PS/WP-4 Report to the Planning Subcommittee

**Advisory Committee on Advanced Television Service
Planning Subcommittee
FCC ATS PS/WP-4**

Minutes of the February 10, 1989 Meeting
(Draft)

PS/WP-4 0052

FIGURE 1. ATV SYSTEM FUNCTIONAL ELEMENTS

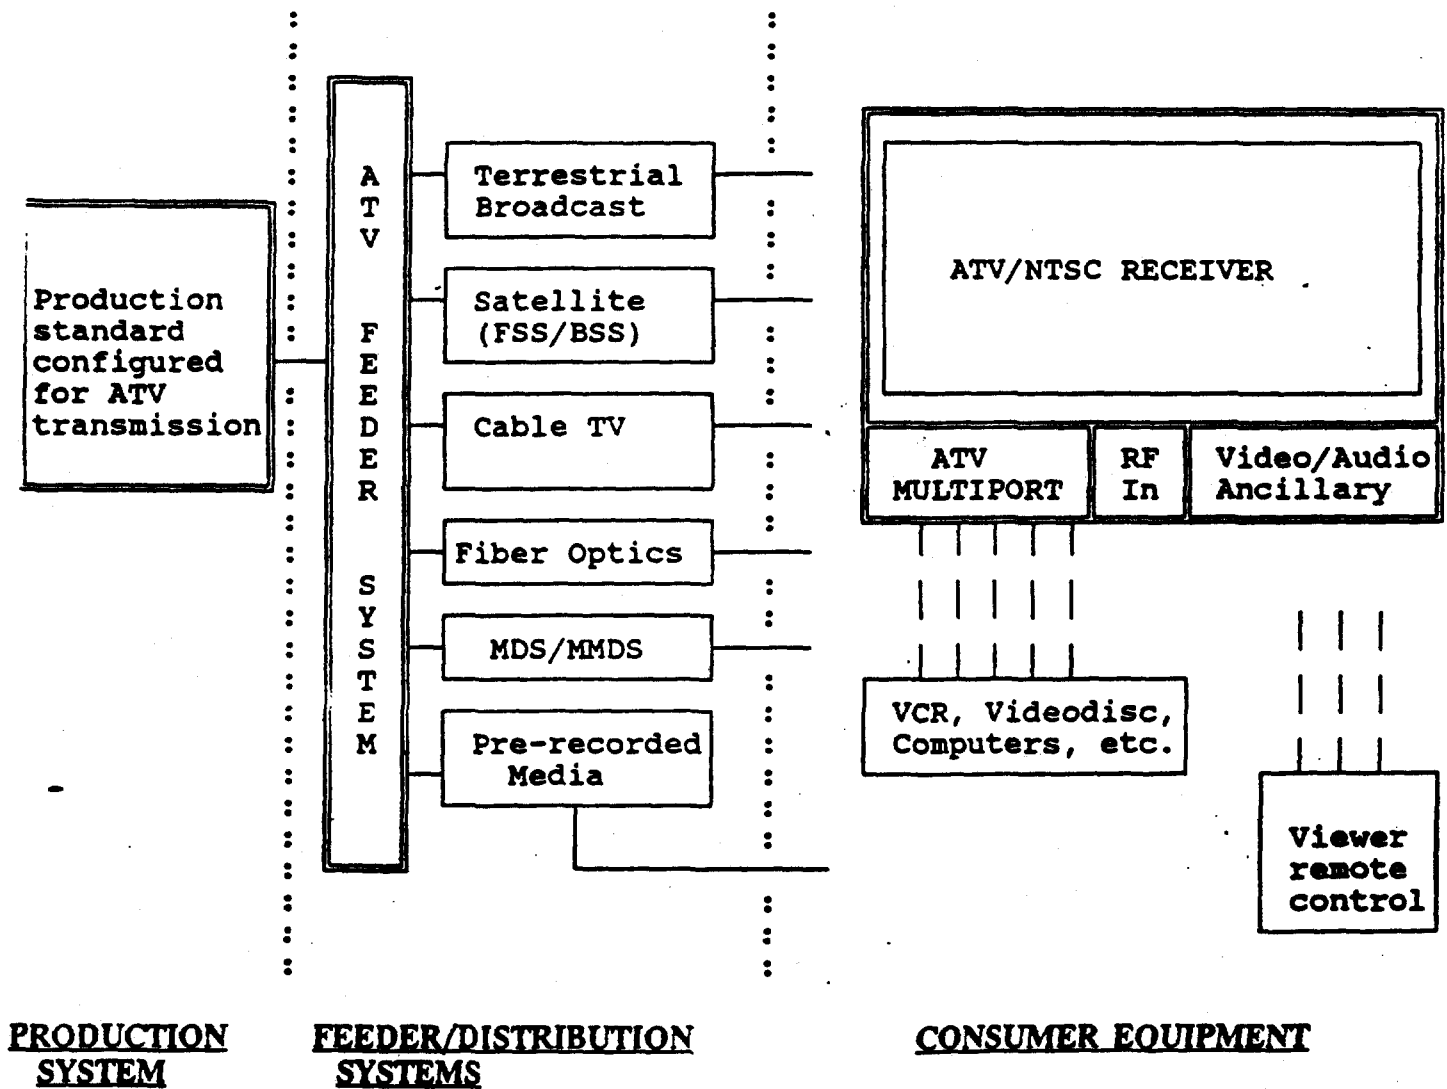
7. Lynn Claudy and others questioned the transmission path shown in Fig.1 of the Chairman's report. Virgil Conanan explained that the figure should be simple enough for non-technical readers to understand the possible ways that consumer will receive ATV. It was agreed that over-simplification is dangerous, and can confuse the reader. Alex Best said that the figure is "symbolic," and illustrates what is described in this document. After some discussion, it was agreed that: 1) the signal flow lines should not be implied in the figure; 2) RF input to the ATV/NTSC receiver should be depicted; and, 3) the more correct title would be " Fig. 1 -- ATV System Functional Elements." The revised drawing is attached.

At the meeting, several deficiencies of Figure 1, titled ATV Distribution System Block Diagram, were noted. Because of this, it was agreed that all signal flow lines would be removed from the drawing, a direct RF antenna port would be diagrammed into the figure, and the title would be changed to ATV System Functional Elements. Admittedly, after doing this there is not much of a drawing left and perhaps there is a better way to show the general relationships between elements. However, the configuration as presented can be misleading as it does not show the possibility for cascaded delivery paths. Also implied is that terrestrial broadcasting signals would be interfaced to an ATV receiver via the Multiport and not directly received at an RF antenna port. This implication is clearly inconsistent with Figure 1 in the Multiport document and has not been considered previously. Needless to say, this is something we are very interested in clarifying in the Chairman's Report.
